# INDIANA DEPARTMENT OF NATURAL RESOURCES CROSLEY FISH AND WILDLIFE AREA DAM IMPROVEMENTS PROJECT

PROJECT NO. ENG1802321631/E020098

PLANS FOR PROJECT RE-BID  
SEPTEMBER 27, 2018

REVISIONS				
No.	DATE	DESCRIPTION	REVISED BY	DOF
1	9/27/2018	REVISE PROJECT ALTERNATES FOR RE-BID

EMERGENCY SPILLWAY - LINE 'E'  
PLAN AND PROFILE

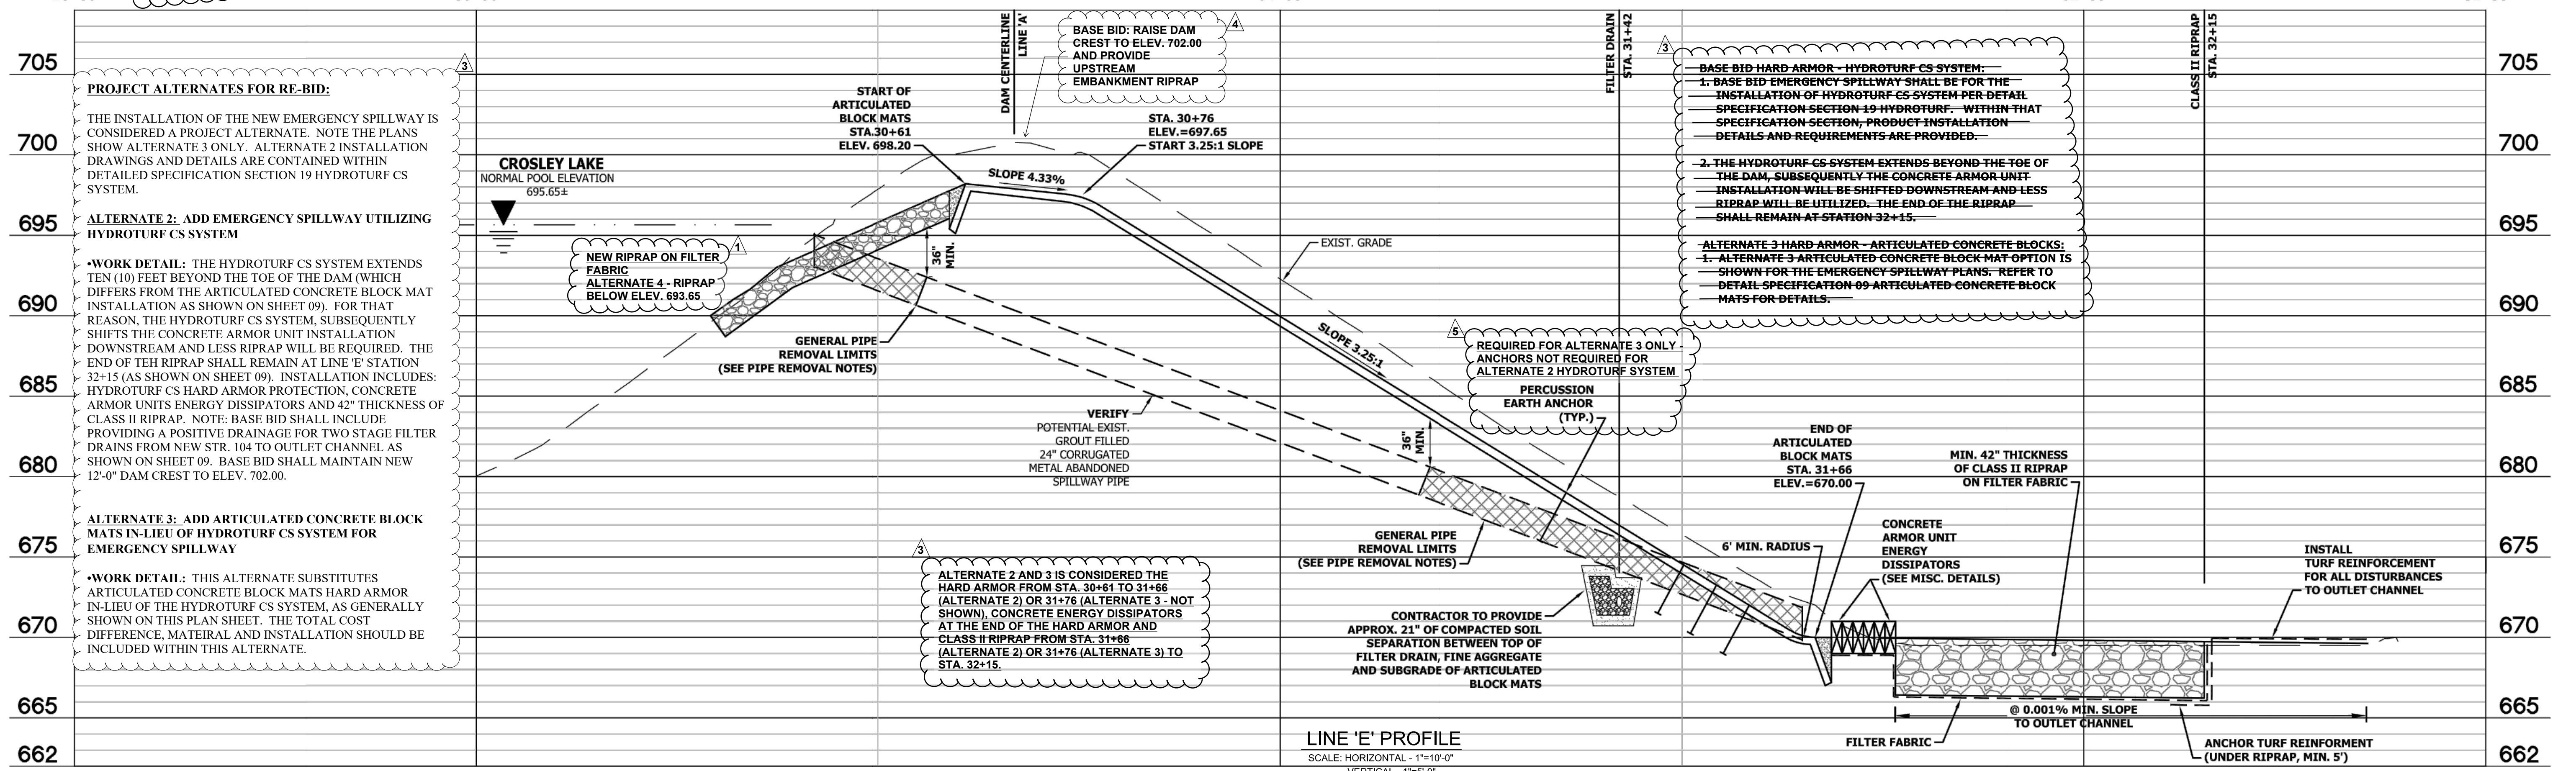
THE INSTALLATION OF THE NEW EMERGENCY SPILLWAY IS CONSIDERED A PROJECT ALTERNATE. NOTE THE PLANS SHOW ALTERNATE 3 ONLY. ALTERNATE 2 INSTALLATION DRAWINGS AND DETAILS ARE CONTAINED WITHIN DETAILED SPECIFICATION SECTION 19 HYDROTURF CS SYSTEM.

**WORK DETAIL:** THE HYDROTURF CS SYSTEM EXTENDS TEN (10) FEET BEYOND THE TOE OF THE DAM (WHICH DIFFERS FROM THE ARTICULATED CONCRETE BLOCK MAT INSTALLATION AS SHOWN ON SHEET 09). FOR THAT REASON, THE HYDROTURF CS SYSTEM, SUBSEQUENTLY SHIFTS THE CONCRETE ARMOR UNIT INSTALLATION DOWNSTREAM AND LESS RIPRAP WILL BE REQUIRED. THE END OF THE RIPRAP SHALL REMAIN AT LINE 'E' STATION 32+15 (AS SHOWN ON SHEET 09). INSTALLATION INCLUDES: HYDROTURF CS HARD ARMOR PROTECTION, CONCRETE ARMOR UNITS ENERGY DISSIPATORS AND 42" THICKNESS OF CLASS II RIPRAP. NOTE: BASE BID SHALL INCLUDE PROVIDING A POSITIVE DRAINAGE FOR TWO STAGE FILTER DRAINS FROM NEW STR. 104 TO OUTLET CHANNEL AS SHOWN ON SHEET 09. BASE BID SHALL MAINTAIN NEW 12'-0" DAM CREST TO ELEV. 702.00.

**WORK DETAIL:** THIS ALTERNATE SUBSTITUTES ARTICULATED CONCRETE BLOCK MATS HARD ARMOR IN-LIEU OF THE HYDROTURF CS SYSTEM, AS GENERALLY SHOWN ON THIS PLAN SHEET. THE TOTAL COST DIFFERENCE, MATERIAL AND INSTALLATION SHOULD BE INCLUDED WITHIN THIS ALTERNATE.

REVISIONS			
No.	DATE	DESCRIPTION	REVISED BY
1	9/27/2018	ALTERNATE 4 - UPSTREAM RIPRAP BELOW EL. 693.65	DOF
2	9/27/2018	LAKE DRAWDOWN IS NOW ALTERNATE 1	DOF
3	9/27/2018	EMERGENCY SPILLWAY IS NOW ALTERNATE 2 & 3	DOF
4	9/27/2018	RAISE DAM AT EMERGENCY SPILLWAY IS BASE BID	DOF
5	9/27/2018	EARTH PERCUSSION ANCHORS FOR ALT. 3 ONLY	DOF

1. BASE BID EMERGENCY SPILLWAY SHALL BE FOR THE INSTALLATION OF HYDROTURF CS SYSTEM PER DETAIL SPECIFICATION SECTION 19 HYDROTURF WITHIN THAT SPECIFICATION SECTION, PRODUCT INSTALLATION DETAILS AND REQUIREMENTS ARE PROVIDED.
2. THE HYDROTURF CS SYSTEM EXTENDS BEYOND THE TOE OF THE DAM, SUBSEQUENTLY THE CONCRETE ARMOR UNIT INSTALLATION WILL BE SHIFTED DOWNSTREAM AND LESS RIPRAP WILL BE UTILIZED. THE END OF THE RIPRAP SHALL REMAIN AT STATION 32+15.

1. ALTERNATE 3 ARTICULATED CONCRETE BLOCK MAT OPTION IS SHOWN FOR THE EMERGENCY SPILLWAY PLANS. REFER TO DETAIL SPECIFICATION 09 ARTICULATED CONCRETE BLOCK MATS FOR DETAILS.

LAKE DRAWDOWN - LINE 'D'  
PLAN AND PROFILE

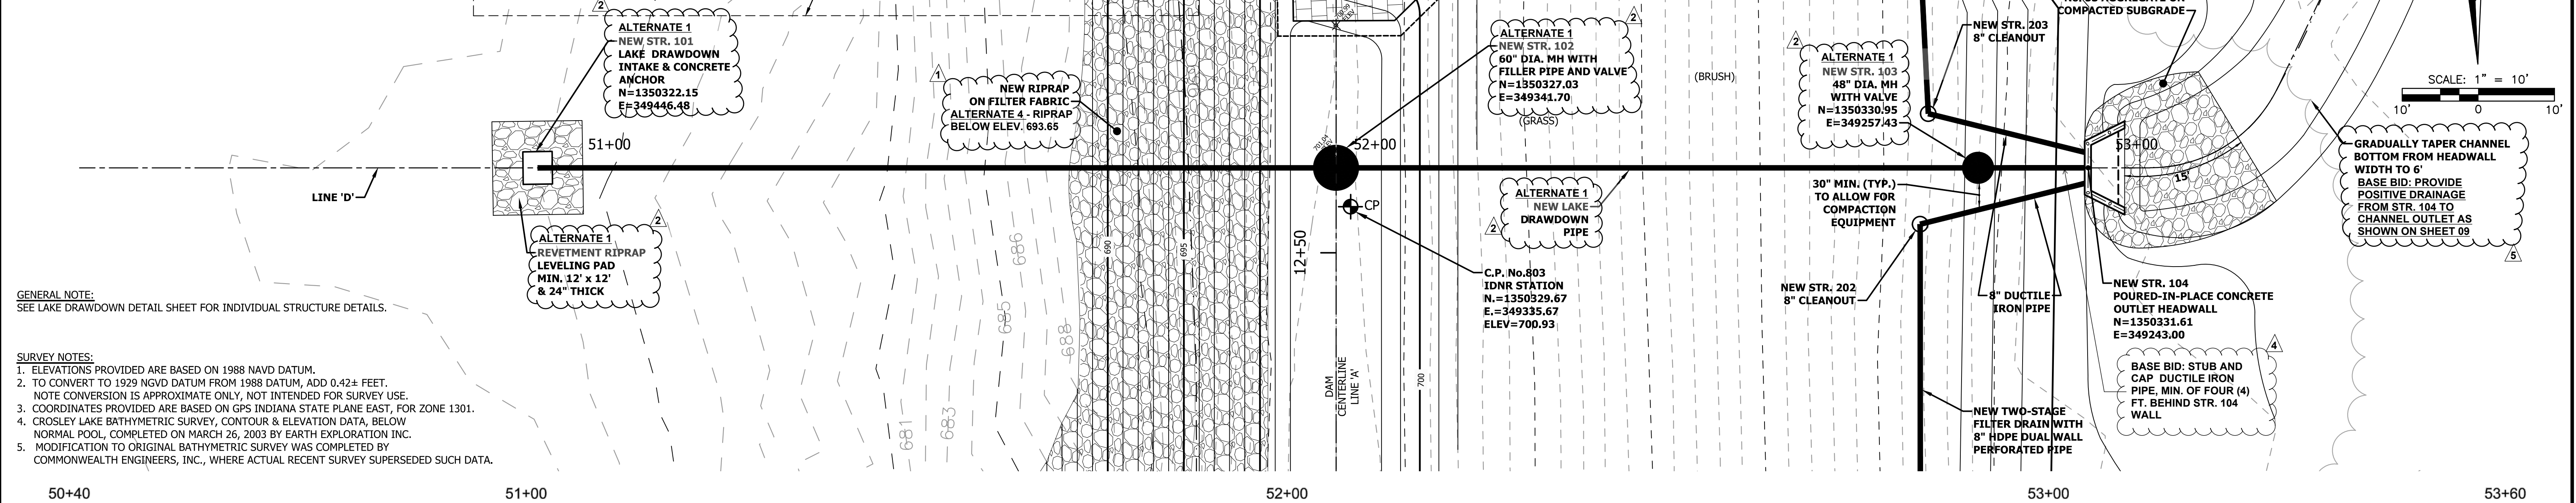
NEW EMERGENCY SPILLWAY IS NOW CONSIDERED PROJECT ALTERNATE.  
ALTERNATE 2: ADD EMERGENCY SPILLWAY UTILIZING HYDROTURF CS SYSTEM  
ALTERNATE 3: ADD ARTICULATED CONCRETE BLOCK MATS IN-LIEU OF HYDROTURF CS SYSTEM FOR EMERGENCY SPILLWAY  
NOTE: BASE BID SHALL INCLUDE PROVIDING A POSITIVE DRAINAGE FOR TWO STAGE FILTER DRAINS FROM NEW STR. 104 TO OUTLET CHANNEL AS SHOWN ON SHEET 09. CLASS II EMERGENCY SPILLWAY RIPRAP IS CONSIDERED A COST ASSOCIATED WITH EMERGENCY SPILLWAY ALTERNATES.

PROJECT ALTERNATES FOR RE-BID:  
ALTERNATE 1: ADD LAKE DRAWDOWN FACILITY  
•WORK DETAIL: INSTALL STR. 101 LAKE DRAWDOWN INTAKE & CONCRETE ANCHOR, REVETMENT RIPRAP LEVELING PAD, NEW STR. 102 60\"/>

No.	DATE	DESCRIPTION	REVISED BY
1	9/27/2018	ALTERNATE 4 - UPSTREAM RIPRAP BELOW EL. 693.65	DOF
2	9/27/2018	LAKE DRAWDOWN IS NOW ALTERNATE 1	DOF
3	9/27/2018	EMERGENCY SPILLWAY IS NOW ALTERNATE 2 & 3	DOF
4	9/27/2018	STR. 104 AND STUB AND CAP 8\"/>

**EMBANKMENT PROFILE WITH RIPRAP PLACEMENT BELOW ELEV. 690.00**  
NOT TO SCALE

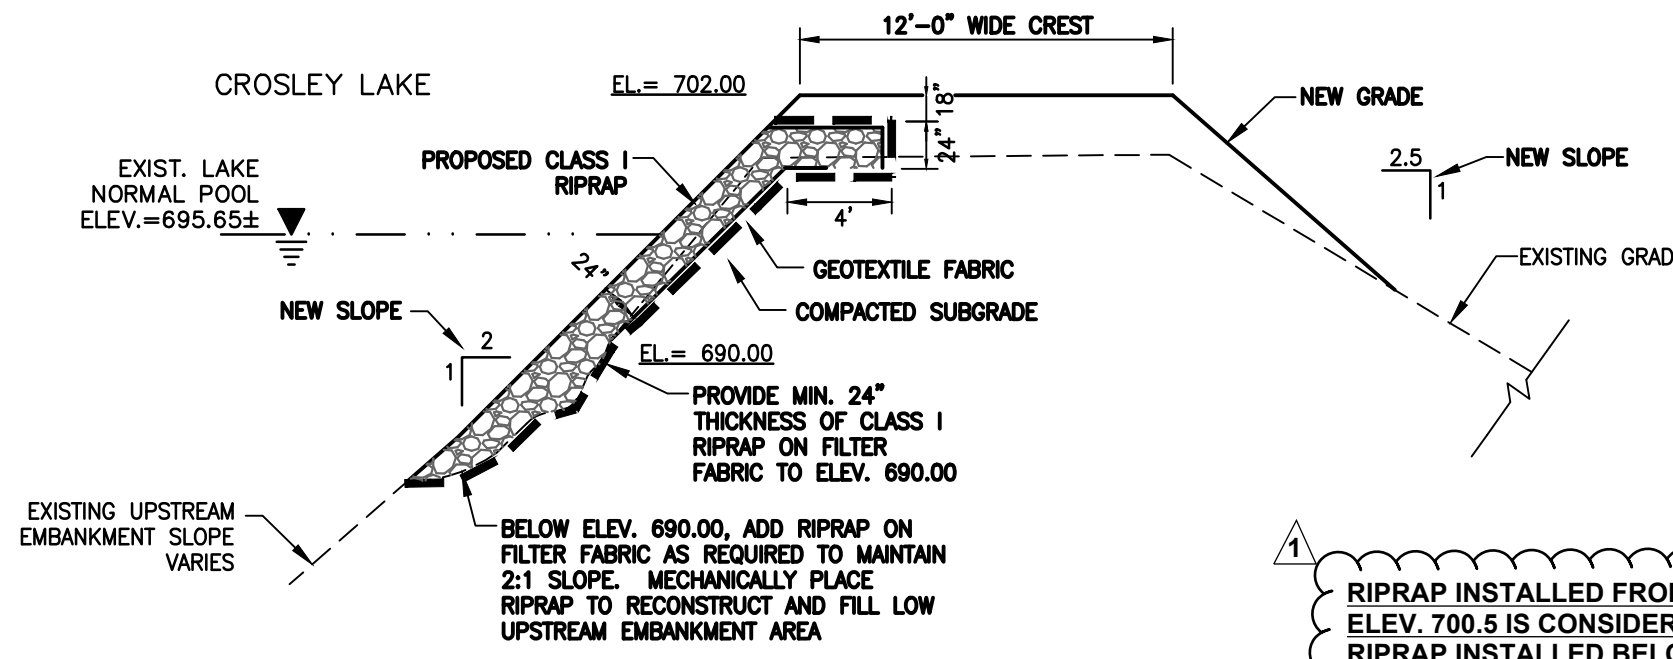
REVISIONS			
No.	DATE	DESCRIPTION	REVISED BY
1	9/27/2018	ALTERNATE 4 - UPSTREAM RIPRAP BELOW EL. 693.65	DOF

DAM CENTERLINE - PROFILE LINE 'A'  
 SCALE: HORIZONTAL - 1"=20'-0"  
 VERTICAL - 1"=5'-0"

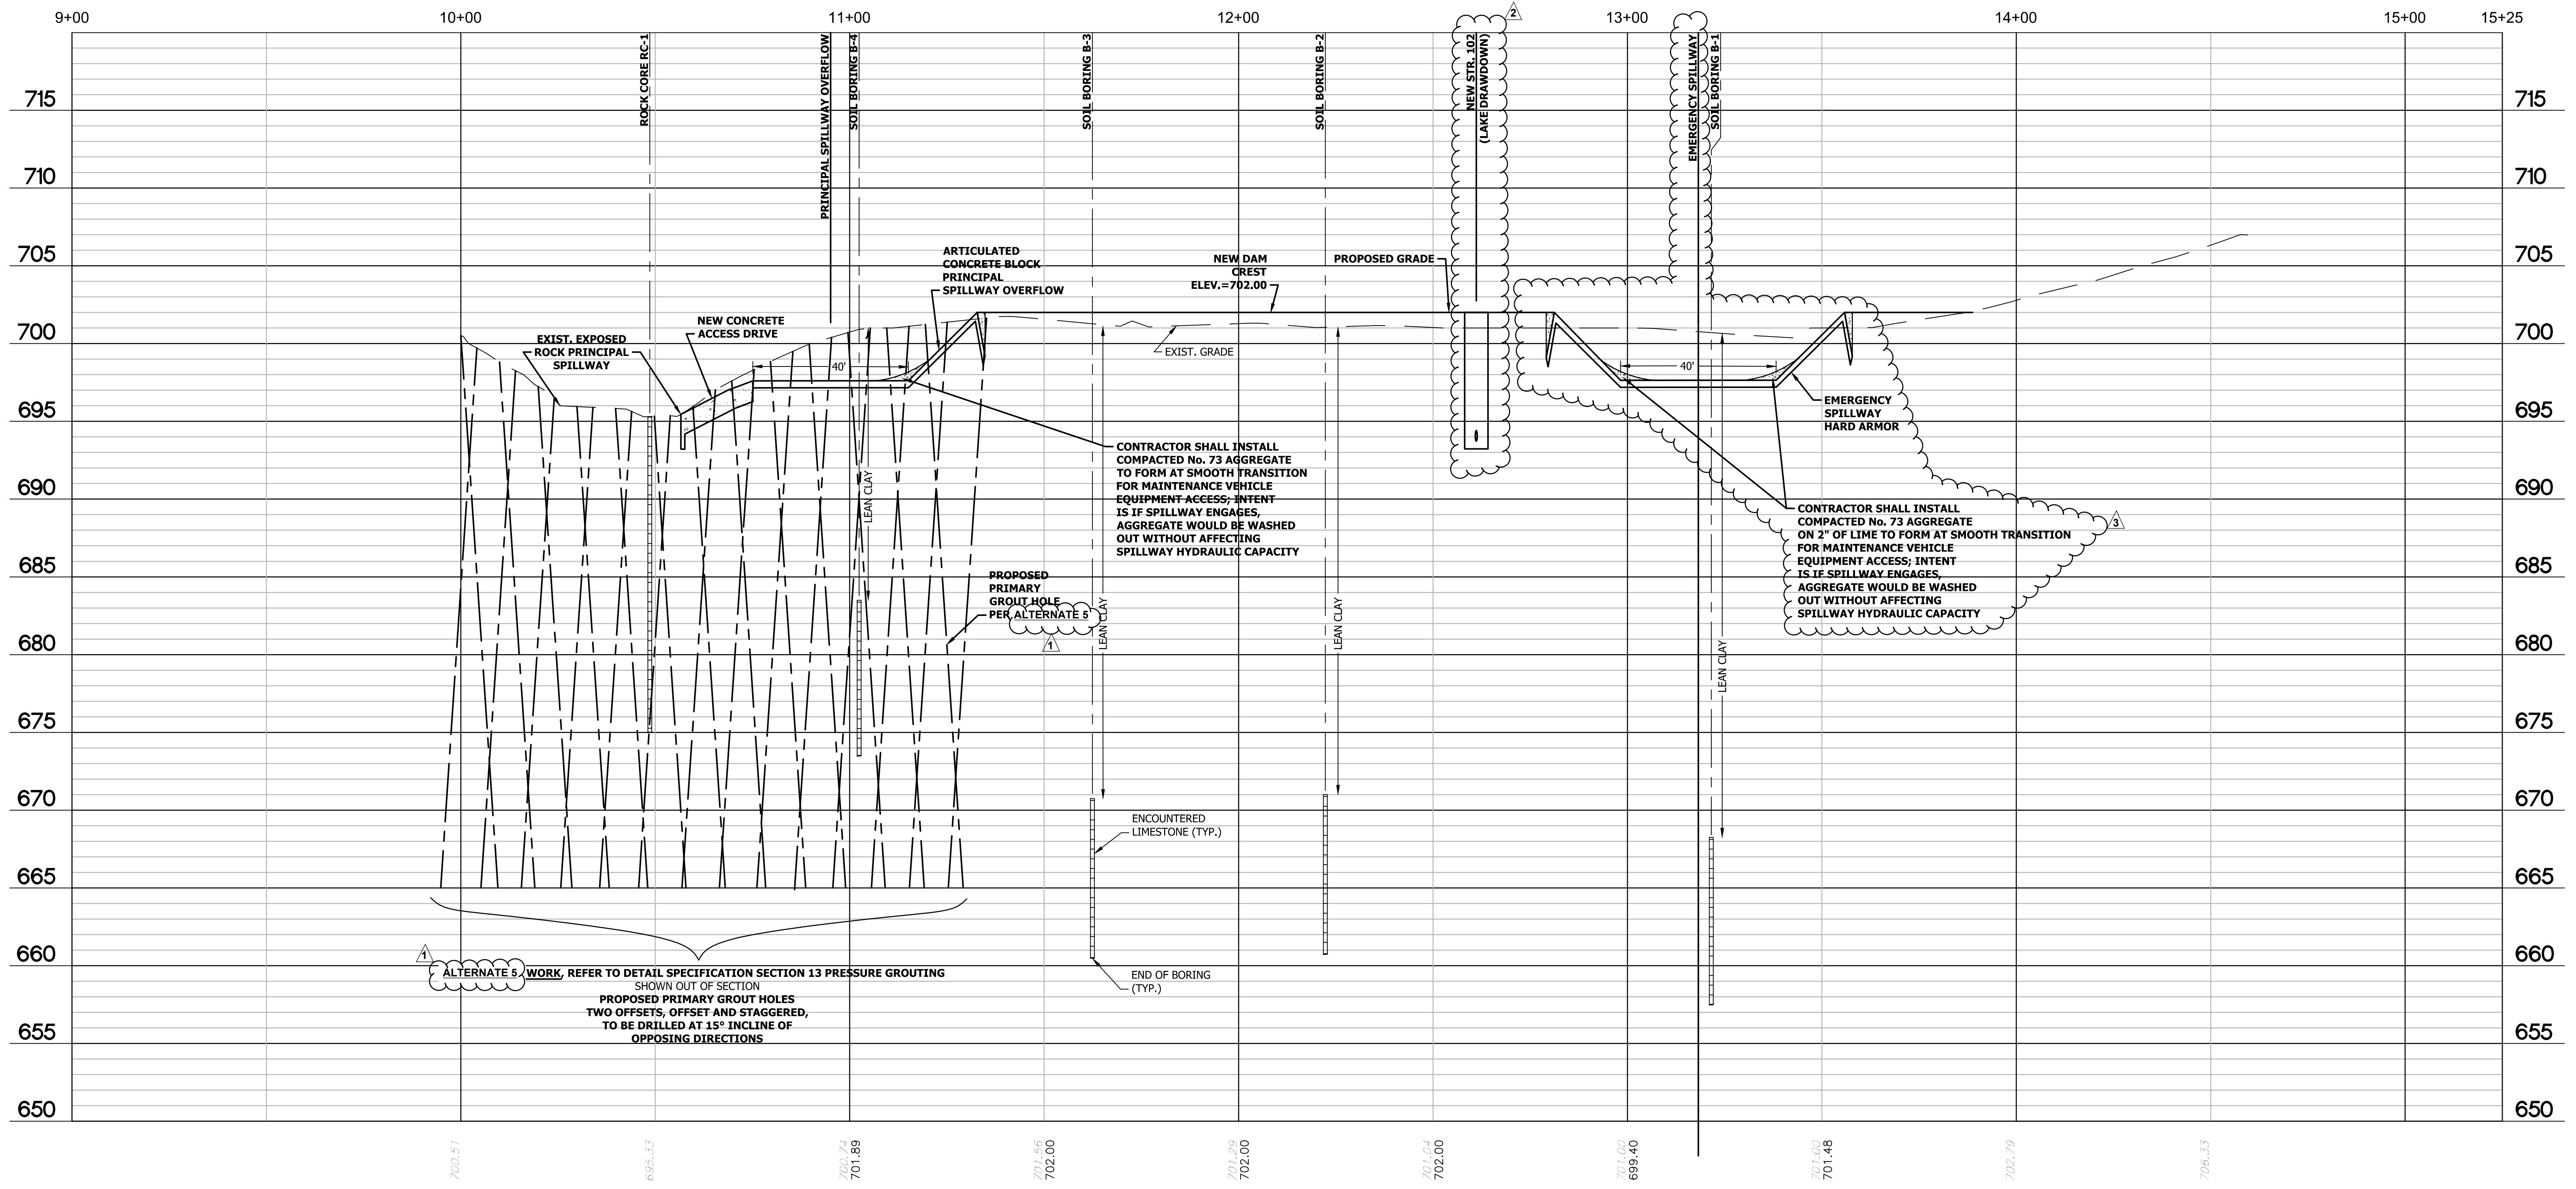
REVISIONS			
No.	DATE	DESCRIPTION	REVISED BY
1	9/27/2018	PREVIOUS BID ALTERNATE 3 IS NOW ALTERNATE 5	DOF
2	9/27/2018	LAKE DRAWDOWN IS NOW ALTERNATE 1	DOF
3	9/27/2018	EMERGENCY SPILLWAY IS NOW ALTERNATE 2 & 3	DOF
